FTAA-2504-1055 - Rangitooopuni Application

Maven Response to Panel RFI 4

14 November 2025

Figure 1: CN Value Change overtime of proposed development vs no development. Note: the time scale is provided for reference only.

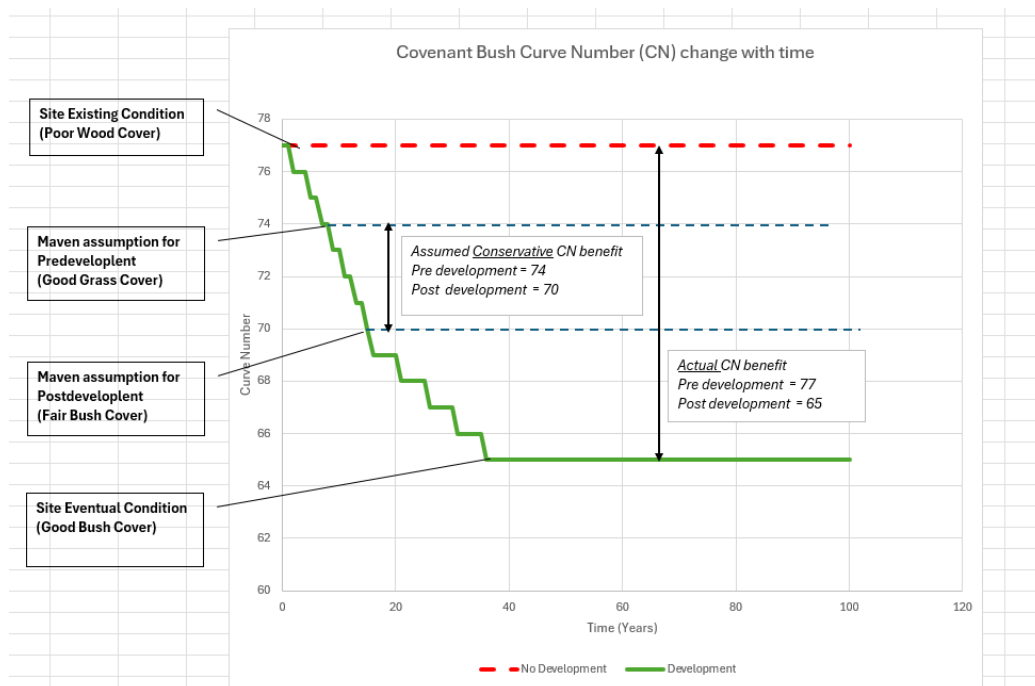
1.2.2 I. The CN value utilised for the pre-development condition.

The above graphs demonstrate the conservatism within the assumptions of the Maven flood modelling completed. The pre-development runoff assumes a lower CN value of 74, whilst the ultimate runoff assumed post development based on CN 70, however, continued benefit and resilience to the downstream catchment will occur as the bush continues to establish, with good bush cover having a CN value of 65 for Class C soils.

1. Maven retains the view that the pre-development nature of the site for clear felled forest has a CN value of 77-80+.
2. Maven has taken a conservative approach and assumed the pre-development CN for the site is CN 74. We remain of the view that this is below the actual CN value based on the current state of the site.
3. Maven has assumed a CN value of CN 70 for planted and protected forest cover. We remain of the view that forest cover which will be protected in perpetuity should have a reduced CN value applied. Bush cover has known benefits in reducing stormwater runoff and providing improved flood resilience outcomes.
4. We remain of the view, that there are significant long-term benefits that will arise from the intended protected bush catchment from that of rotational forestry. Refer to Figures 1 and 2 under Section 1.2.2, above for a visual representation of this.
